10.17.2012 DESIGN REVIEW RECOMMENDATION MEETING
521 2ND AVE W / DPD PROJECT # 3012746

Address : 521 2nd Ave W
DPD Project Number : 3012746
Contact : Radim Blazej, Caron Architecture
Zoning : NC3-40

LIVE/WORK DIAGRAMS

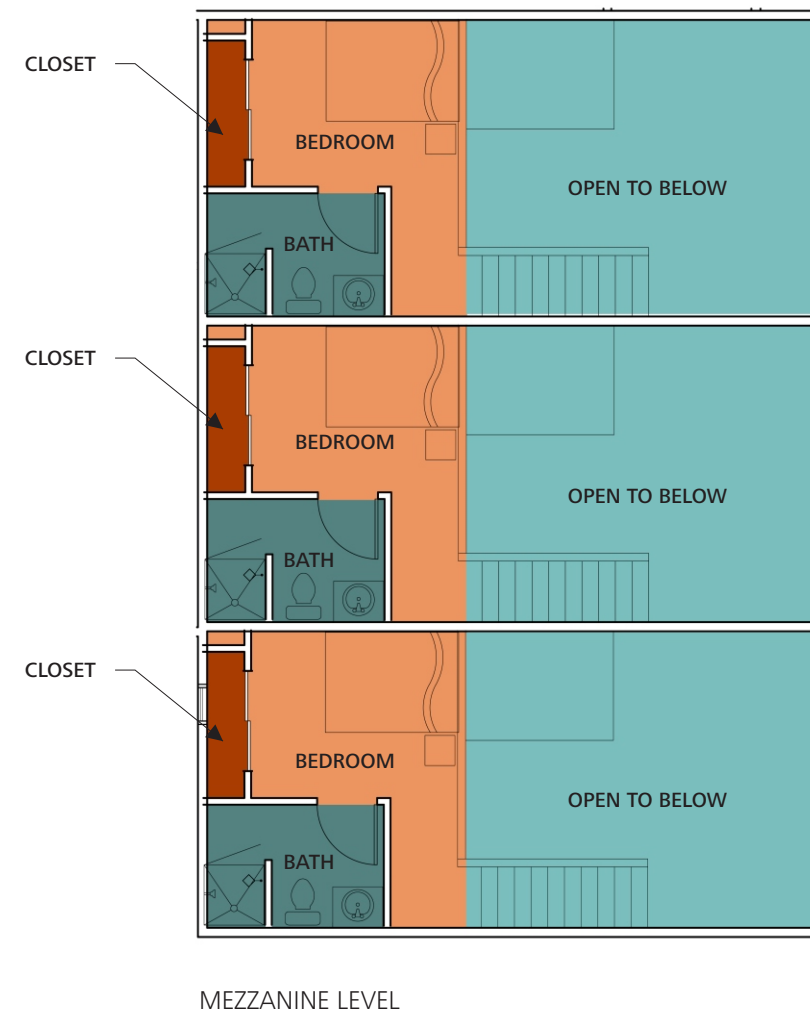
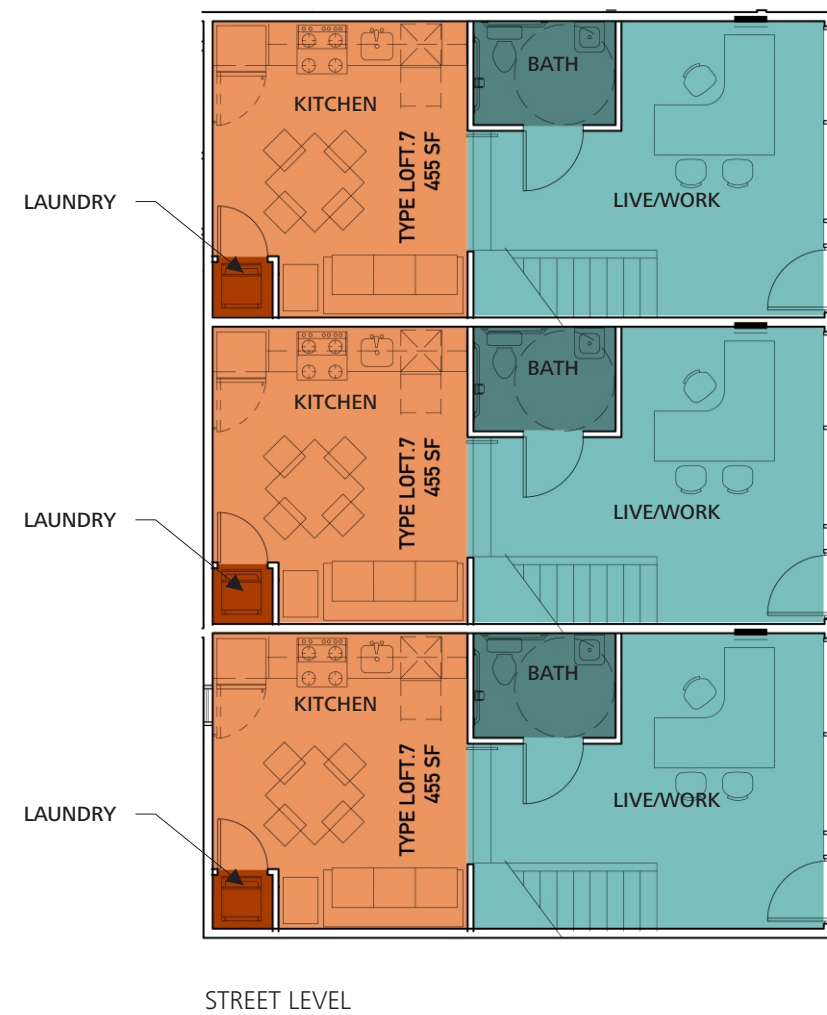
23.47A 008 B3	Non-Residential uses must be 30' deep with a floor to floor height of 13'	The proposed design for the live / work units has a floor to floor height of 16'-0" minimum, for the front 16'-0" of the spaces. The floor to floor height of the mezzanine is 8'-0" minimum	N	Allow the live / work mezzanine to have a ceiling height of less than 13'.	A similar configuration in the Uptown Neighborhood was presented on 9/27/2012 and was considered advantageous by the Board. This configuration gives a visual connection between the loft, commercial area, and street-front. The floor to floor height at the front of the unit exceeds the requirement by 4'-6", providing greater transparency than required. Mezzanines also do not count as floor area in the SBC.
